Sections 2

DRAWING TITLE:
Section 3

P/A	12/04/2024	Issue For Development Application																																	
B	8/05/2024	Issue For RFI																																	
C	11/07/2024	Issue For RFI																																	
D	15/07/2024	Issue For RFI																																	
E	30/07/2024	Issue For RFI																																	
F	23/08/2024	Issue For RFI																																	
G	10/04/2025	Issue for S4.55																																	
CLIENT: WINIM Developments Pty Ltd																																			
101 pbd architects P - 02 9698 8140 E - info@pbdarchitects.com.au W - pbdarchitects.com.au Level 2, 52 Allison Street, Surry Hills NSW 2010 ABN 36 147 035 550 Nominated Architect: Paul Buljevic NSW 7768																																			
PROJECT: Residential Flat Building 1 Gatacre Ave & 1-5 Allison Ave, Lane Cove

DRAWING TITLE: Photomontage - Allison Avenue																																			
<table><tr><td>DRAWING BY:</td><td>CHECKED BY:</td><td>DATE:</td></tr><tr><td>GR</td><td>Checked by KA</td><td>10/04/2025</td></tr><tr><td>SCALE:</td><td>DRAWING NO:</td><td>ISSUE:</td></tr><tr><td>NTS</td><td>DA410</td><td>G</td></tr><tr><td>PROJECT N

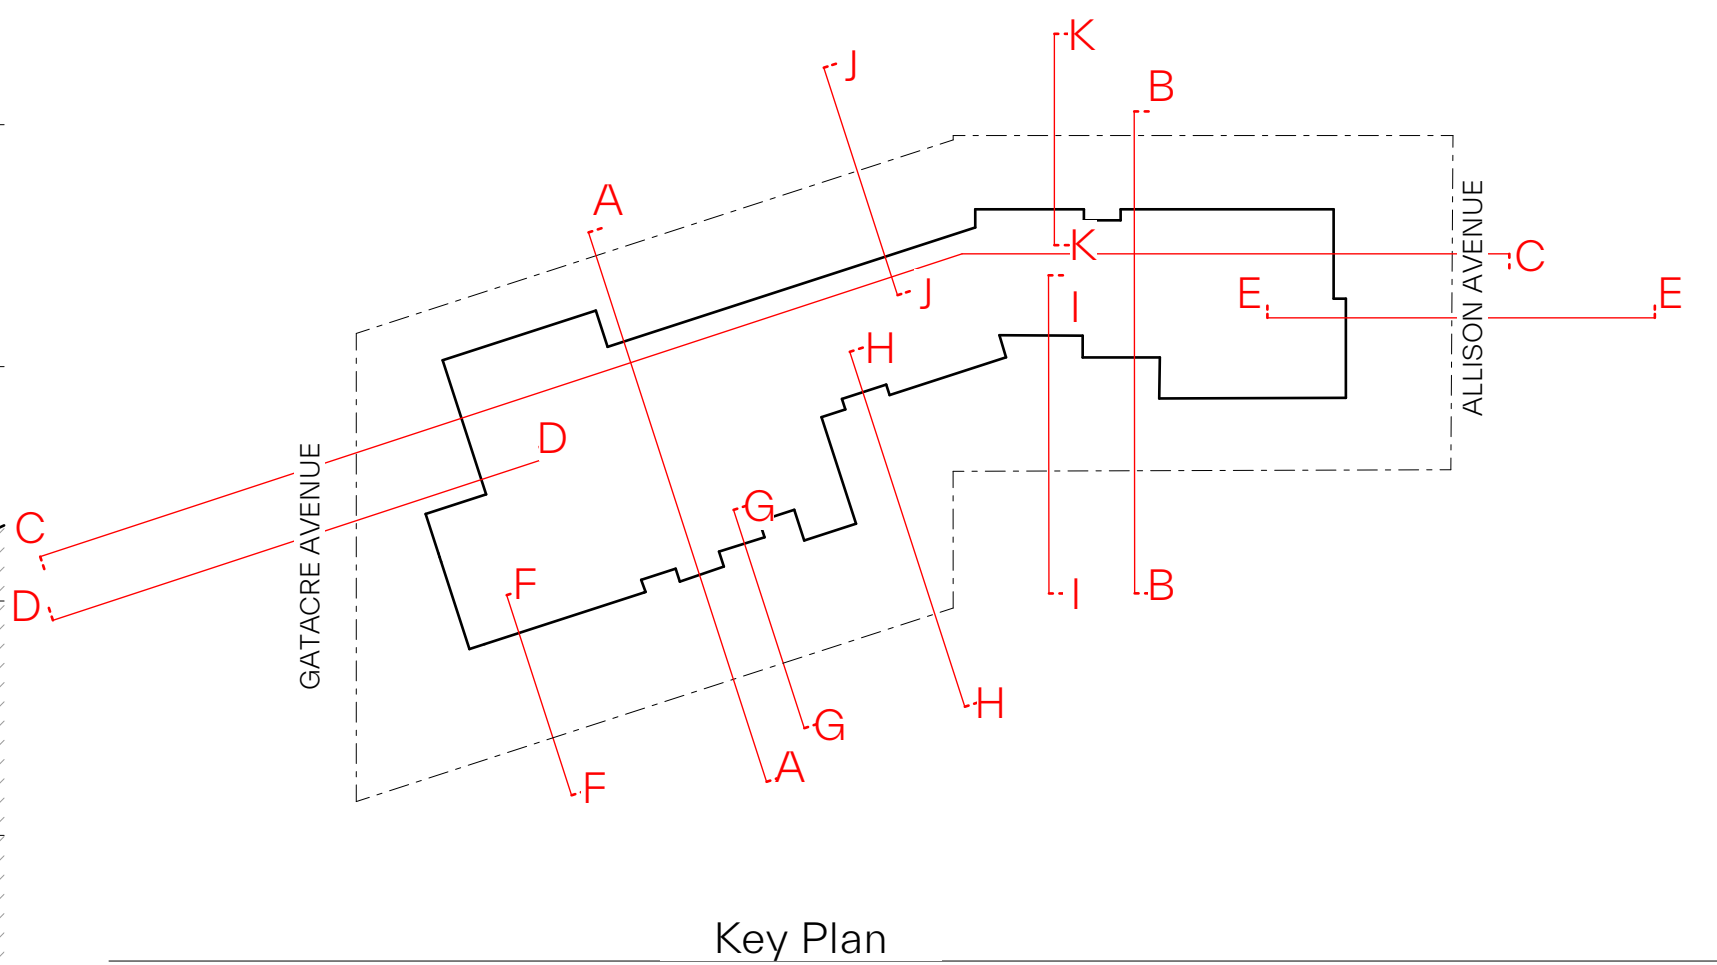
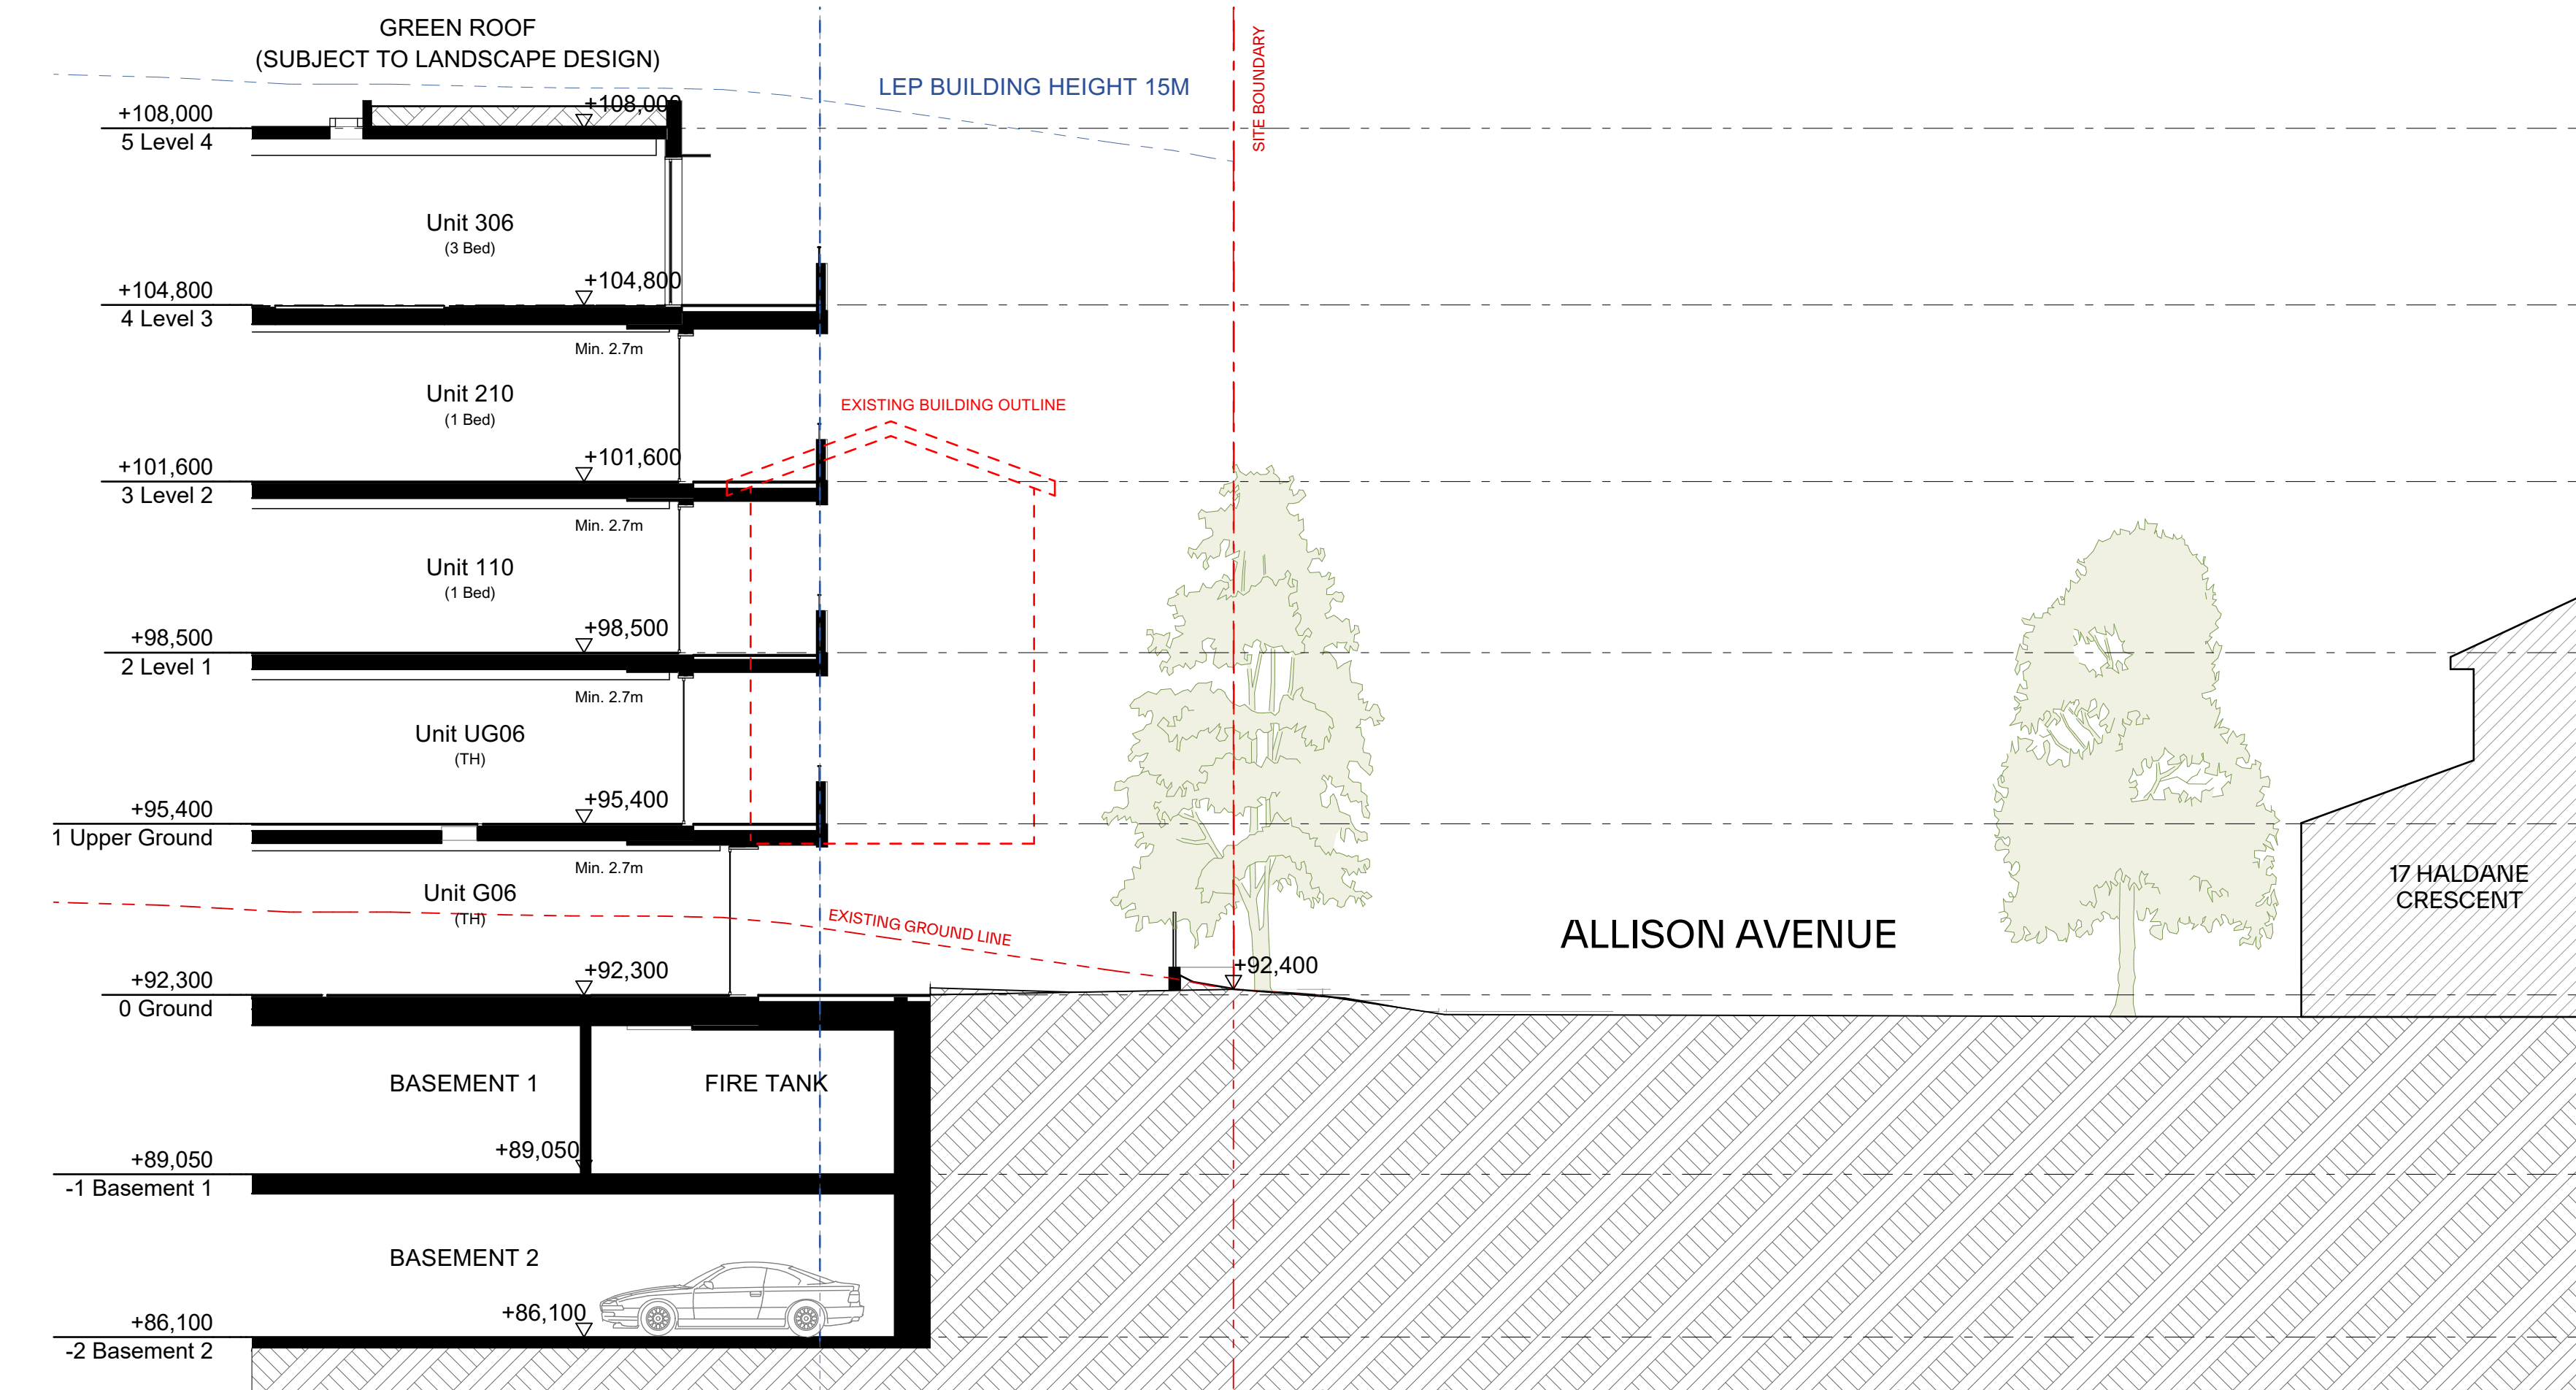
- 12. RELOCATION OF ACCESSIBLE BAYS AND STORAGE - 2 ACCESSIBLE PARKING BAYS HAVE BEEN MOVED FROM THE EAST SIDE OF THE BUILDING TO THE WEST SIDE.
- 13. SLAB R/L CHANGED - SLAB R/L LOWERED BY 50MM TO DECREASE CEILING CLEARANCE.

- 14. RELOCATION OF BIKE RACKS - BIKE RACKS HAVE BEEN REPOSITIONED WITHIN THE DEVELOPMENT.
- 15. A - SHOWING WALL ALIGNMENT WITH BASEMENT BELOW - NO CHANGES IN DEEP SOIL FROM EXISTING TO NEW FOUNDATION.

- 16. ADDITION OF STORAGE AREA - A NEW STORAGE SPACE HAS BEEN ADDED BENEATH THE APPROVED TERRACES ON THE UPPER GROUND FLOOR.
- 17. RECONFIGURED COMMUNAL AREA - THE ENTERTAINMENT AREA - THE ENTERTAINMENT SPACED INTO AN ENTERTAINMENT SPACE AND A FITNESS SPACE HAS BEEN ADDED, AND THE CELLAR AREA HAS BEEN RECONFIGURED FOR IMPROVED FUNCTIONALITY.

- 18. RELOCATED MECHANICAL FAN EXHAUST - THE MECH FAN EXHAUST HAS BEEN MOVED TO THE EXISTING EXHAUST LOCATION.
- 19. APARTMENT SIZE INCREASE - APARTMENT SIZES HAVE BEEN EXPANDED BENEATH THE APPROVED TERRACES ON THE UPPER GROUND FLOOR.

- 20. STANDARDIZED APARTMENT LAYOUTS - INTERIOR LAYOUTS HAVE BEEN AMENDED FOR UNIFORMITY ACROSS ALL APARTMENTS.
- 21. TERRACE MODIFICATION - A PREVIOUSLY NON-TRAFFICABLE TERRACE HAS BEEN CONVERTED INTO A PRIVATE GARDEN SPACE FOR UNITS 302, 401 AND 402.

- 22. AMENDED ROOFTOP AREA DESIGN - THE BBQ AREA HAS BEEN REPOSITIONED FOR BETTER ACCESSIBILITY AND FUNCTIONALITY. GENERAL UTILITY SKIN AND RUBBISH BIN ADDED TO COSY.

- 23. INCREASED APARTMENT SIZE - UNIT 205 HAS BEEN EXPANDED.
- 24. ADDED HEIGHTLIGHT WINDOWS - A HEIGHTLIGHT WINDOW HAS BEEN ADDED TO THE WALL BETWEEN THE COMMUNAL OFFICE AND THE COMMUNAL OFFICE TO IMPROVE SOLAR AMENITY.

- 25. AC UNIT RELOCATION - AIR CONDITIONING UNITS HAVE BEEN MOVED TO THE ROOF LEVEL.
- 26. REDUCTION IN SOLAR PANEL CAPACITY - THE NUMBER OF PV PANELS HAS BEEN REDUCED FROM 175 TO 130, DECREASING ROOFTOP SOLAR CAPACITY FROM 87KW TO 55KW.

- 27. IMPROVED LANDSCAPING - LARGER TREES HAVE BEEN INTRODUCED ALONG THE BOUNDARY WITH 17 ALLISON AVENUE. BORDERSHAW HAS BEEN REALIGNED AND TIMBER FENCE TO INCORPORATE.
